DEVELOPMENT REVIEW APPLICATION

For Office Use Only	
PROJECT NO. DR-11-07	STAFF CONTACT Sara J
NON-REFUNDABLE FEE(S) N/A \$500	REFUNDABLE DEPOSIT(S) N/A
	TOTAL \$500

1817 and 1823 Willamette Falls Dr. - Exterior Alteration Narrative
Response to Staff's Summary of May 5, 2011 Pre-Application Meeting
Prepared for Sara Javoronok, West Linn Associate Planner and the West Linn HRB
Applicant: Darren Gusdorf, Icon Construction and Development
Date submitted: May 6th, 2011

SHEET NO. **A1**

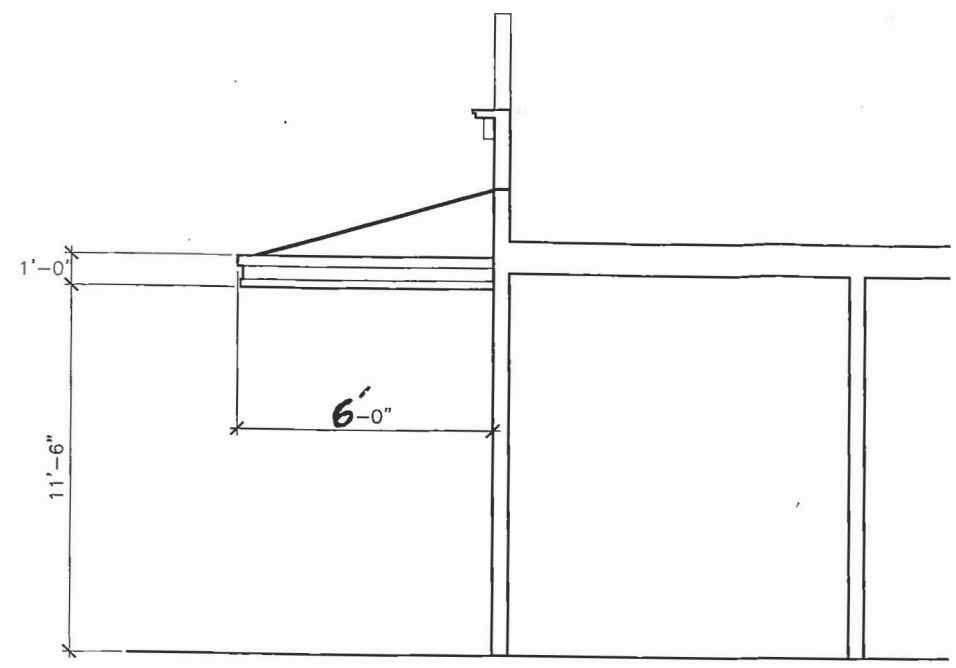
Staff Comment: *For 1823 Willamette Falls Drive, the code requires the doors to be recessed three to five feet back from the building line. Please show or state how much the doors will be recessed.*

Staff Comment: *The sign location is noted on the elevation drawing. The size and location will not be approved as part of this process, a separate sign application will be required. Staff notes that signage is limited to 10 percent of the square footage of the front elevation.*

Applicant Response: *The existing doors are currently recessed 2'-6". The recessed alcove will not be altered (currently constructed on foundation wall).*

Applicant Response: *We will seek sign approval through a separate process.*

Photo #1 – 1817 side existing door and window openings

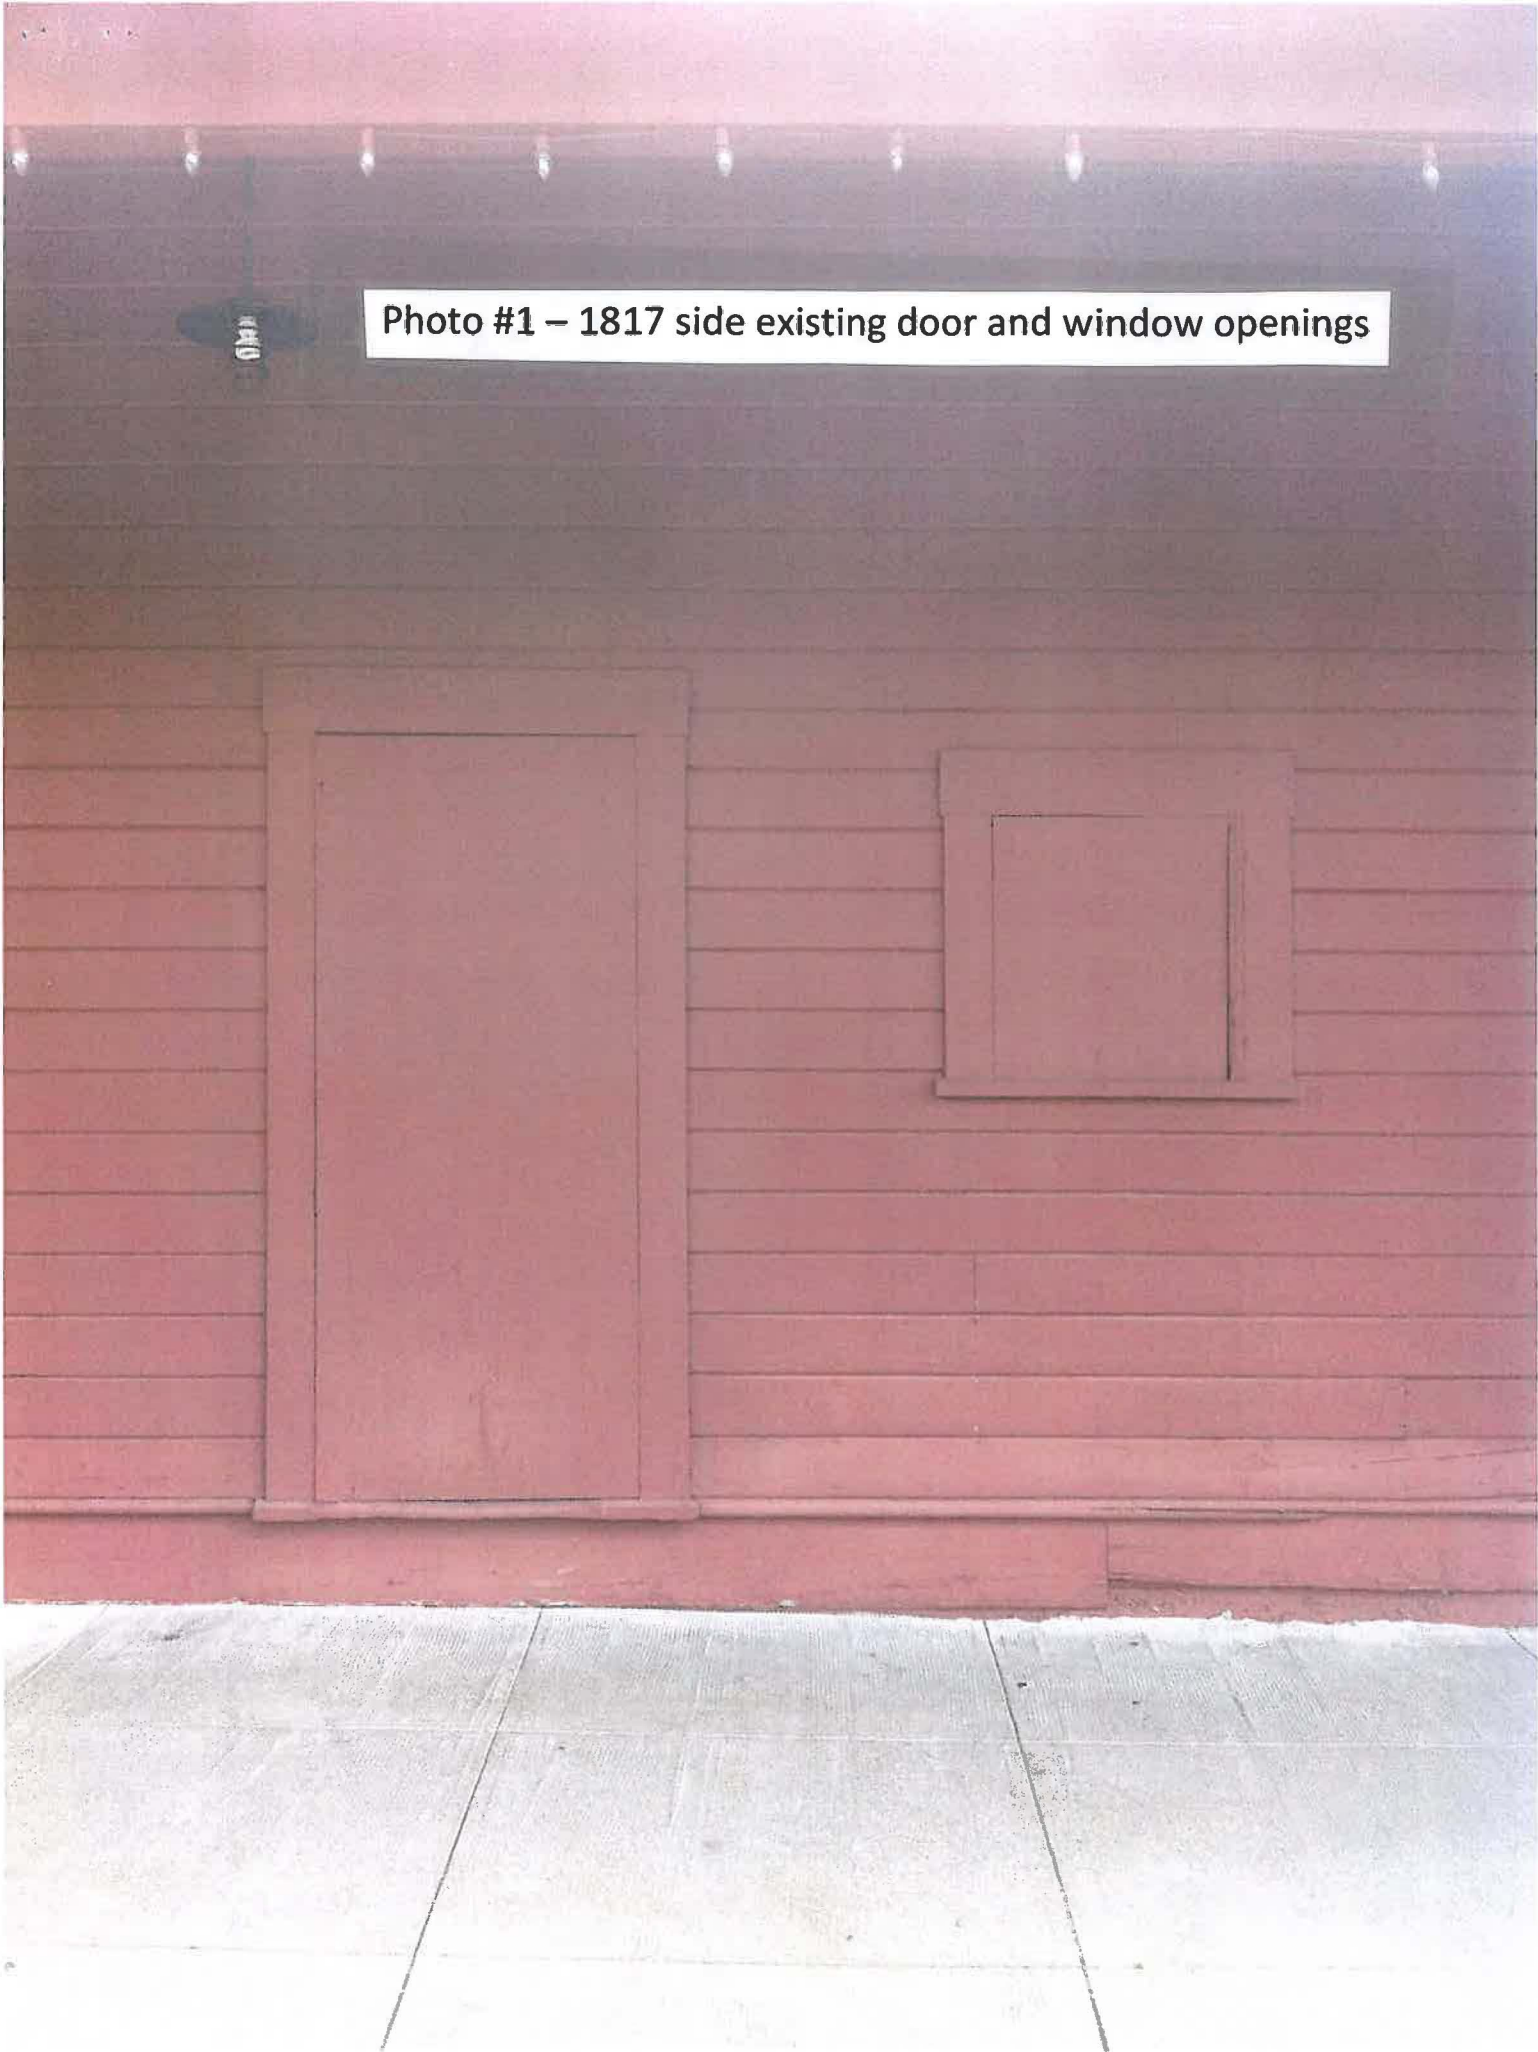
Staff Comment: *For 1817 Willamette Falls Dr. if evidence of the original milk chute is found staff would encourage the applicant to restore it to a historic appearance. If not found, the proposed four true divided light windows are acceptable.*

Applicant Response: *We do not have evidence for what this window was used for. I have provided the cut sheet for the four true divided light window in cut sheet "A" – SAME AS ABOVE.*

Photo #7 – Historic District steel awning 1877

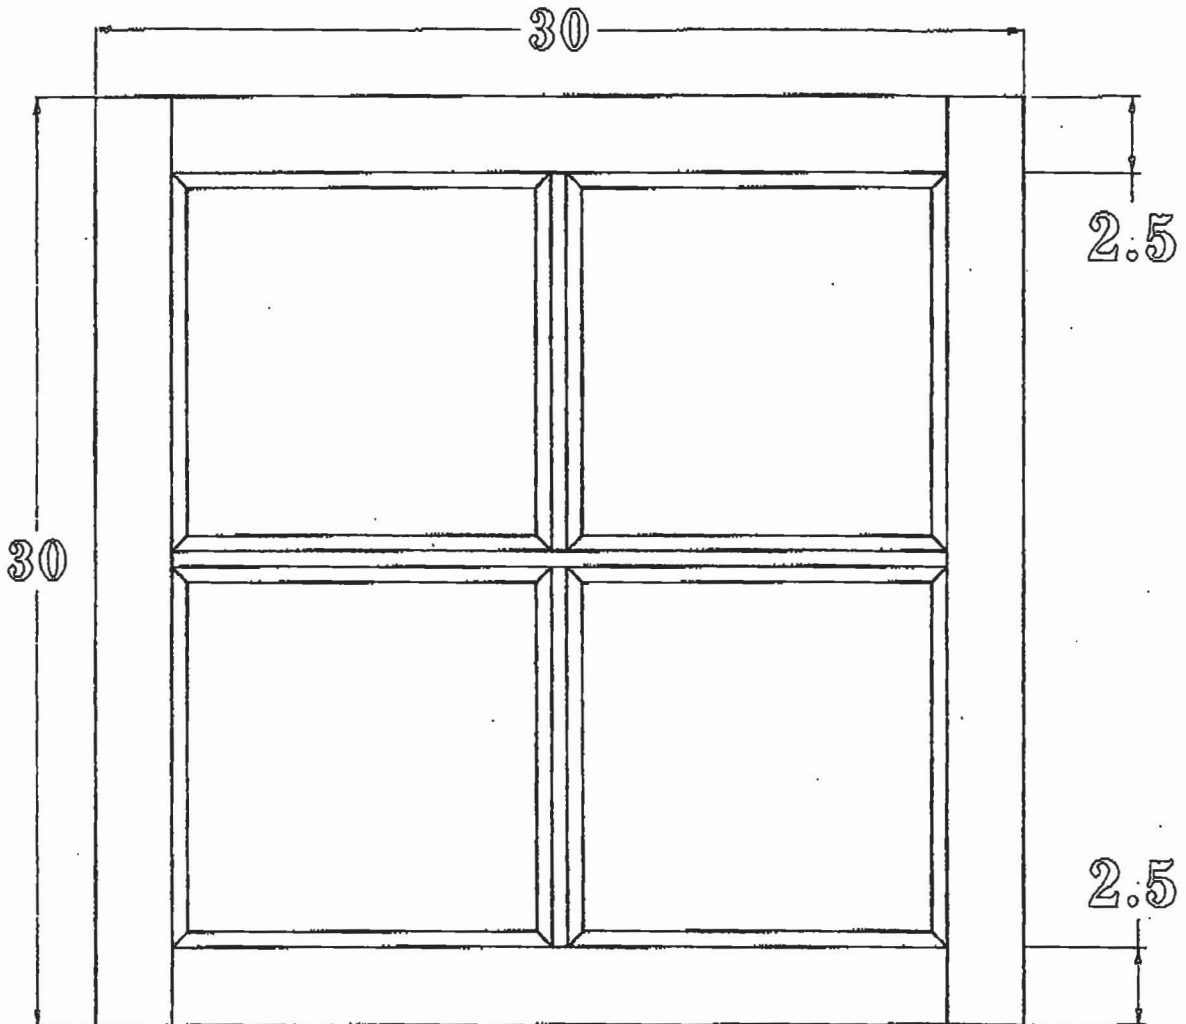
Staff Comment: *There is precedence for steel/metal awnings in the Historic District and Commercial District. The awning at 1705 Willamette Falls Drive is a good example of a steel awning.*

Applicant Response: *Yes, there are other steel awnings in the commercial historic district. As seen at 1705, 1877 and 1914 Willamette Falls Dr. (per pictures #6, #7 and #8).*

CUT SHEET "B"

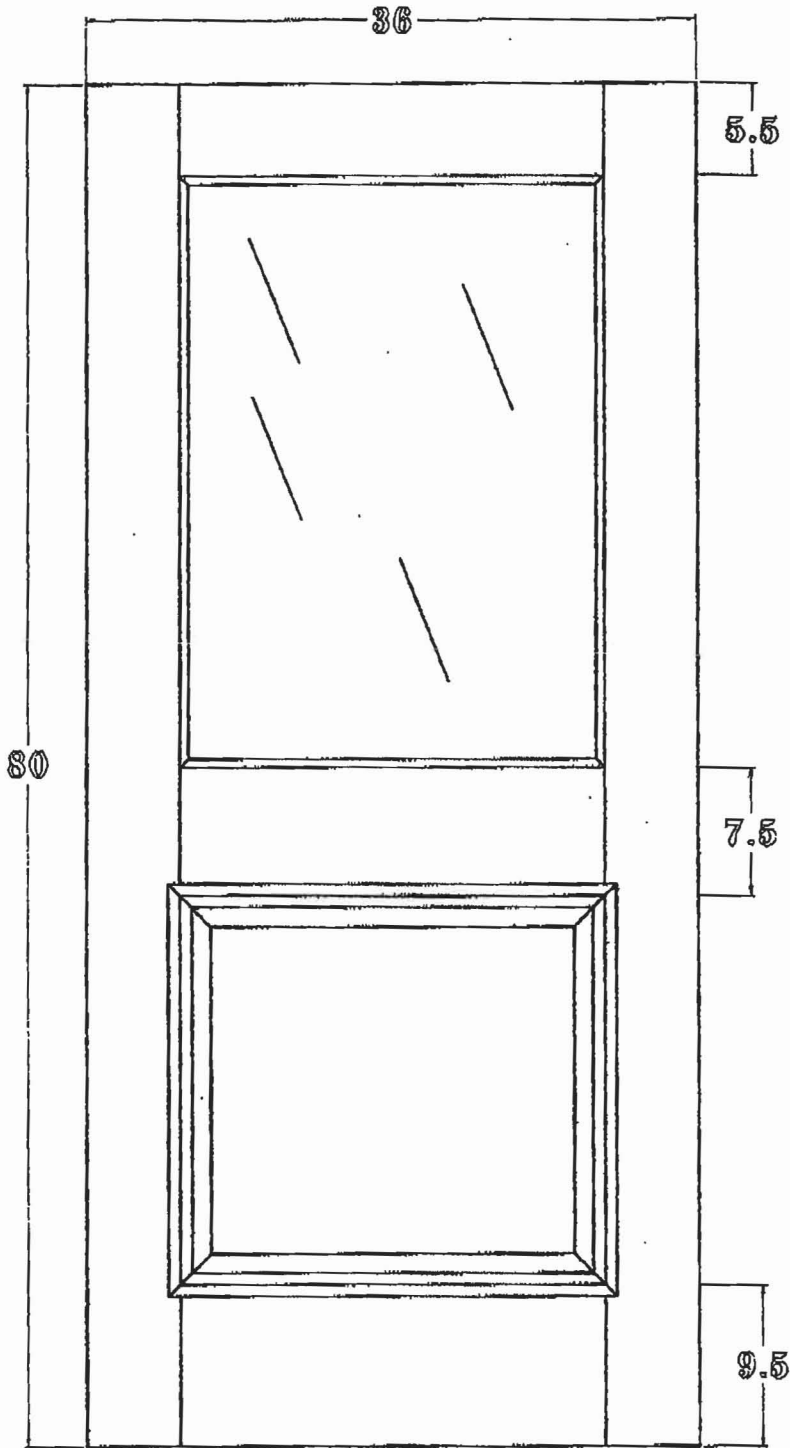
Staff Comment: *Please provide cut sheets/photos for the can lighting and up lighting.*

Applicant Response: *Proposed can lights are shown in picture #3. Proposed surface mount fixtures are shown in picture #4 and cut sheet "B." (2) 3" proposed up lights are proposed at the top of the awning to illuminate the sign above. See cut sheet "D".*
